Access Report

**High Technology Industrial  
Development**

Part of Proposed Lot 200/212  
Newton Parade  
WILLIAMTOWN NSW

For: EJE Architecture  
Ref: PAA 23489

Figure 2 | Overall Site Plan

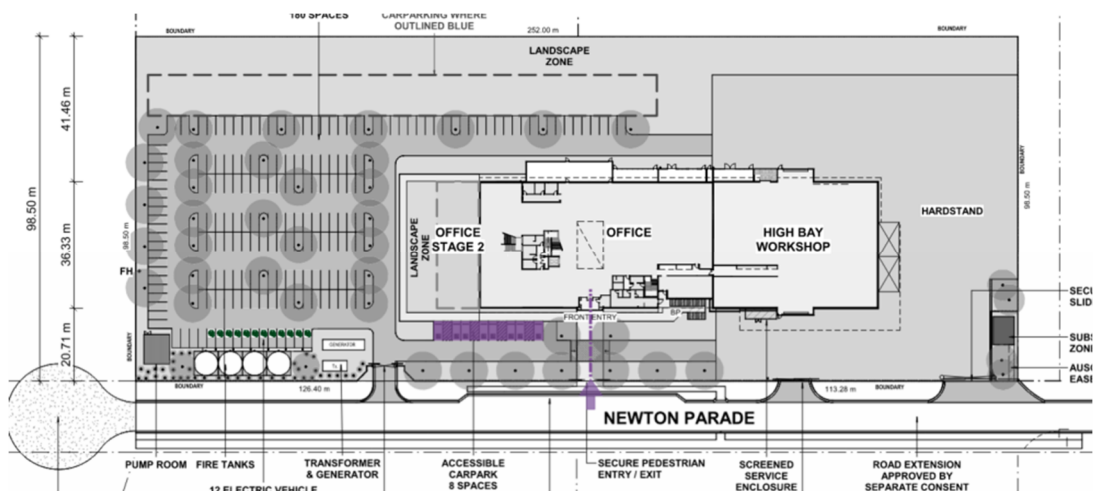
An accessible path of travel is provided to the building entrance from the allotment boundary along Newton Avenue via a formed footpath. Site levels indicate that on-grade access is achievable.

An accessible path of travel is provided to the building entrance from the accessible carparking via a formed footpath. Site levels indicate that on-grade access is achievable.

Footpaths that form the approach to the building are a in excess of 1500mm wide as a minimum and site levels indicate a level surface is achievable.

On grade parking is provided on the southern side of the building. Eight (8) spaces are nominated as accessible spaces and are located closest to the building entrance.

The overall configuration of the accessible carparking achieves compliance with current legislation including dimensions of the space and associated shared areas, chevron markings and provision of a bollard.
